# Product Change Notification (PCN)

PCN #: 5G-202**5** Date: **May 8**, 2025

Part	Description
453-00107	Module, 50 Series, WB50NBT with No Software
453-00023	Module, 50 Series, WB50NBT with Custom Software
453-00033	Module, 50 Series, WB50NBT with Custom Software
453-00034	Module, 50 Series, WB50NBT with Custom Software
453-00146	Module, 50 Series, WB50NBT with Custom Software
DVK-WB50NBT	Development Breakout board WB50NBT module included

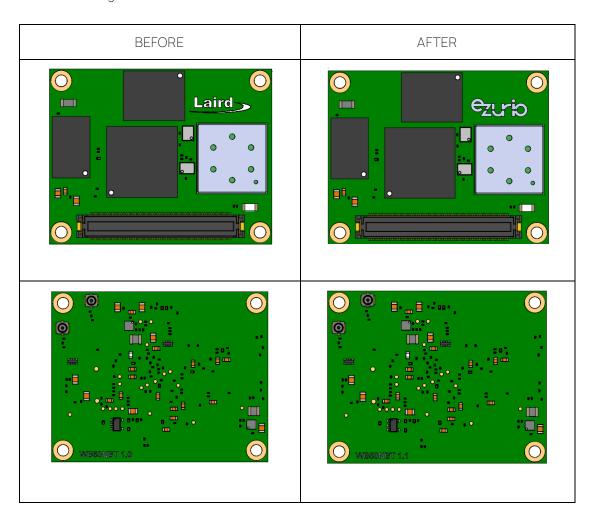
- On the PCB, update revision silkscreen from 1.0 to 1.1 and logo from Laird to Ezurio. It will be consumed by running change.

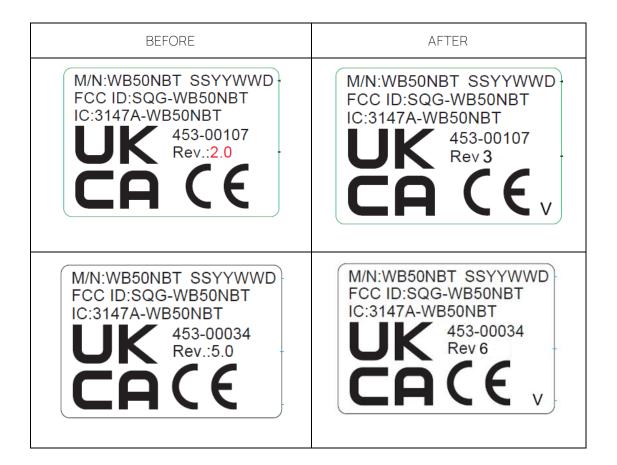
- 453-00107/453-00034
  - On the device label, major update product revision from Rev,:X.X to Rev X and adds a symbol "V" to identify Made in Vietnam

- 453-00023/453-00033/453-00146
  - On the device label, major update product revision from 453-00023-R4.0 to 453-00023-R5, 453-00033-R2.0 to 453-00033-R3, 453-00146-R2.0 to 453-00146-R3

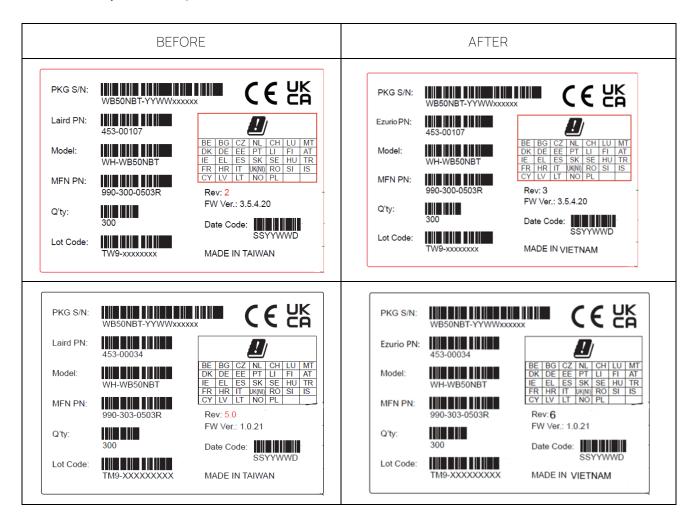
- 453-00107/453-00034
  - On the box labels
    - o Replace Laird PN to Ezurio PN
    - o Change from MADE IN TAIWAN to MADE IN VIETNAM
    - Major revision updates 453-00107 from Rev: 2 to Rev: 3, 453-00034 from Rev: 5.0 to Rev: 6

- 453-00107/453-00034
  - On the shipping carton label,
    - o Replace Manufacturer from Laird Connectivity to Ezurio
    - o Replace Laird PN to Ezurio PN
    - o Replace origin from Taiwan to Vietnam

#### DVK-WB50NBT

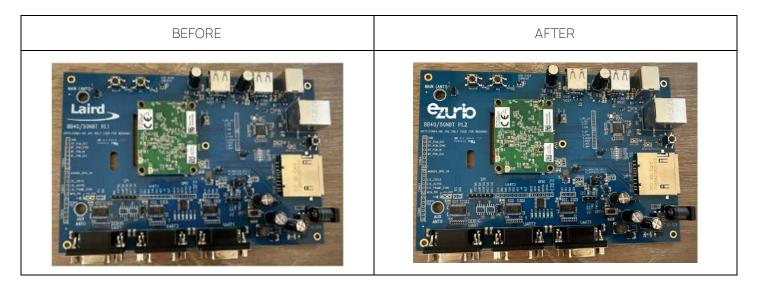
- On the Dev Board PCB, update revision silkscreen from BB40/50NBT R1.1 to BB40/50NBT R1.2
